Access Compliance Report

Public Rights-of-Way

(Curb Ramps)

Intersection ID: 47908	Main Street: UNIVERSITY_CITY_BV	Cross Street: E_MALLARD_CREEK_CHURCH_RD	Location: NE
ADA ID: 79B5339B970C	Ramp Type: Perp	Initial Pass/Fail: Fail	Overall Compliance: No
			Severity Score: 21.25

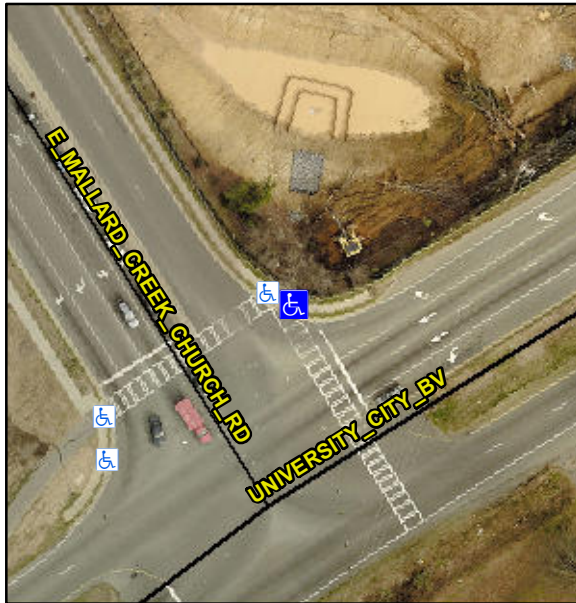
Not Found, R304.5.1, R304.2.2

Compliance	Description	Data	Compliance	Description	Data
N/A	Ramp Length (in)	70.0	No	Ramp Slope (%)	9.3
No	Ramp Width (in)	40.5	Yes	Ramp XSlope (%)	1.3
N/A	Flare Type LT	N/A	N/A	Flare Type RT	N/A
N/A	Flare Slope LT (%)	N/A	N/A	Flare Slope RT (%)	N/A
N/A	Flare Traversable LT?	N/A	N/A	Flare Traversable RT?	N/A
N/A	Landing Length (in)	N/A	N/A	DWS Provided?	N/A
N/A	Landing Width (in)	N/A	N/A	DWS Contrast?	N/A
N/A	Landing Slope (%)	N/A	N/A	DWS Length (in)	N/A
N/A	Landing X Slope (%)	N/A	N/A	DWS Full Width?	N/A
N/A	Landing Curb? (Y/N)	N/A	N/A	DWS Offset (in)	N/A
N/A	Shared Landing?	N/A			
N/A	Gutter Ponding?	N/A	N/A	Gutter Slope (%)	N/A
N/A	Gutter Lip Ht (in)	N/A	N/A	Gutter X Slope (%)	N/A
N/A	Painted X Walk1?	Yes	N/A	Painted X Walk2?	N/A
	X Walk 1 Direction	To SE		X Walk 2 Direction	N/A
N/A	X Walk 1 Width (in)	113.0	N/A	X Walk 2 Width (in)	N/A
	X Walk 1 Slope (%)	0.3		X Walk 2 Slope (%)	N/A
	X Walk 1 X Slope (%)	1.6		X Walk 2 X Slope (%)	N/A

Remove & Replace Entire Ramp.
